TENNESSEE VALLEY AUTHORITY

BELLEFONTE NUCLEAR PLANT UNITS 1 AND 2 - REVISED RESPONSE TO DEVIATIONS 50-438/83-10-01, 50-439/10-01, PORTIONS OF THE FIRE PROTECTION SYSTEMS DO NOT CONFORM TO THE DESIGN CRITERIA OF THE APPLICABLE NFPA CODE - 50-438/83-10-03, 50-439/10-03, EXTERIOR FIRE PROTECTION WATER SYSTEM WAS NOT INSTALLED UNDER A QA/QC PROGRAM - 50-438/83-10-05, 50-439/83-10-05, IMPROPER FIRE DAMPER INSTALLATION

BELLEFONTE NUCLEAR PLANTS UNITS 1 AND 2
REVISED RESPONSE TO DEVIATION 50-438/83-10-01, 50-439/83-10-01
PORTIONS OF THE FIRE PROTECTION SYSTEMS DO NOT CONFORM TO
THE DESIGN CRITERIA OF THE APPLICABLE NFPA CODE

FIGURE 1

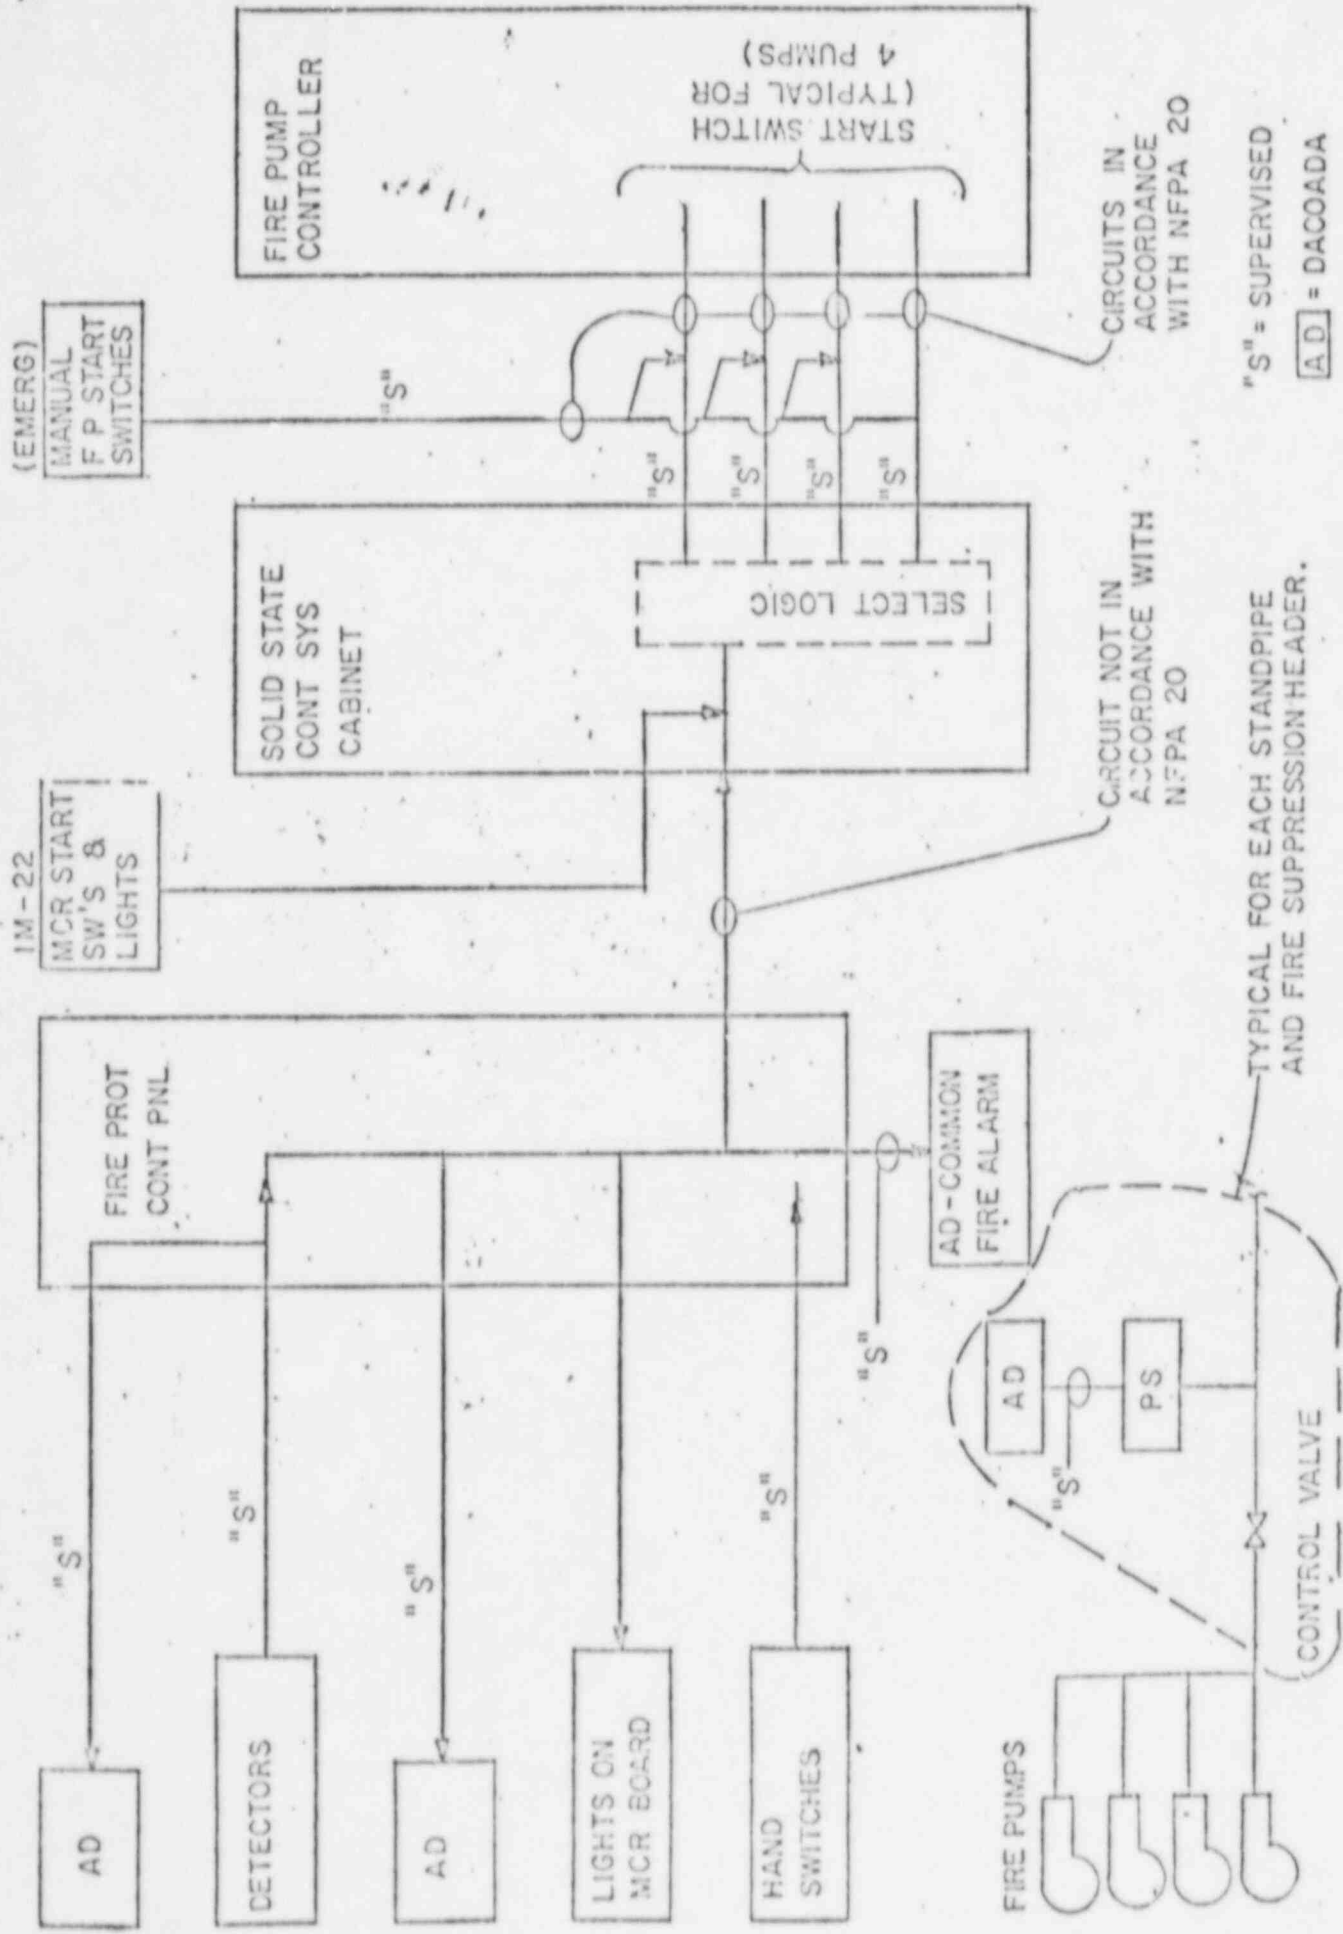
- a. The electrical circuits from the fire detection control panels to the sprinkler system actuation panels for the preaction control valves are not electrically supervised as required by NFPA-13, Sprinkler Systems, Section 5-3.5.4.
- b. The sprinkler piping systems are not supervised as required by NFPA-13 Section 5-3.5.4.

The fire pump actuation circuits are routed from two fire detection control panels in the auxiliary instrument rooms through the Solid-State Control System (SSCS) cabinets to the pump controllers. The starting circuits from the SSCS cabinets to the pump controllers are wired to normally closed contacts and are arranged such that breakage, disconnection, or loss of power to the starting circuits will cause automatic continuous operation of the fire pumps. Circuits from the fire detection panels to the SSCS cabinets are wired to normally open contact, and failure of these circuits will not cause automatic start of the fire pumps. However, if an input signal to the detection panels requiring fire pump start fails to generate a corresponding output to the SSCS, the control room operator is notified that an alarm condition exists on that panel. This is transmitted over a common alarm circuit from the detection panels to the Data Acquisition and Control, Operation Recording, Annunciation, Data Logging, Access Control, and Fire Detection System (DACODA). Appropriate manual actions will then be taken to start the fire pumps. All input signals to the detection panels are supervised. In addition, the fire pumps can be started from the main control room through the SSCS. If the SSCS should fail, the fire pumps can also be started by an emergency bypass switch located in the immediate vicinity of the SSCS cabinets. This switch is a normally closed contact and the circuit is arranged such that any breakage, disconnection, or loss of power will cause automatic continuous operation of the fire pumps. The fire pump controller is also wired so that a loss of power to the controller will cause automatic continuous operation of the fire pumps.

TVA believes that the unique arrangement of the Bellefonte Nuclear Plant's SSCS in conjunction with the level of supervision of fire detection input circuitry to the detection panels and plant operating procedures provide a level of protection that meets the intent of NFPA 20-1976, Section 9-5.2.4 (FSAR Code of Record).

The following Fire Pump Start Block Diagram (Figure 1) with accompanying explanatory notes illustrates the fire pump start circuitry inputs.

1. In event of either a detector actuation or manual fire pump start initiation, there is an alarm on DACOADA (supervised) for the individual condition and a common alarm (supervised).

2. There is a pressure-switch indication downstream of each valve (supervised) which can be compared with the alarm in item 1 to ensure pumps have started and valve has opened. (Exceptions are standpipes which do not have valves).

3. If pumps start, there will be indication on main control room board (MCR) IM-22. If not started, operator can attempt to start them from: (1) MCR (nonsupervised circuit), (2) manual fire pump start switch downstream of solid state control system (SSCS) (supervised), or (3) at the fire pump controller.

4. In summary, there are supervised circuits to alarm the operator that the pumps should be started and status (most of which is supervised) to show that they have started. If they did not start, there is both nonsupervised start circuits in MCR and supervised start circuits at the SSCS cabinet.

5. There are 20,000-gallon tanks on top of the turbine building which would gravity-feed most areas which would automatically fill from the four electric pumps.
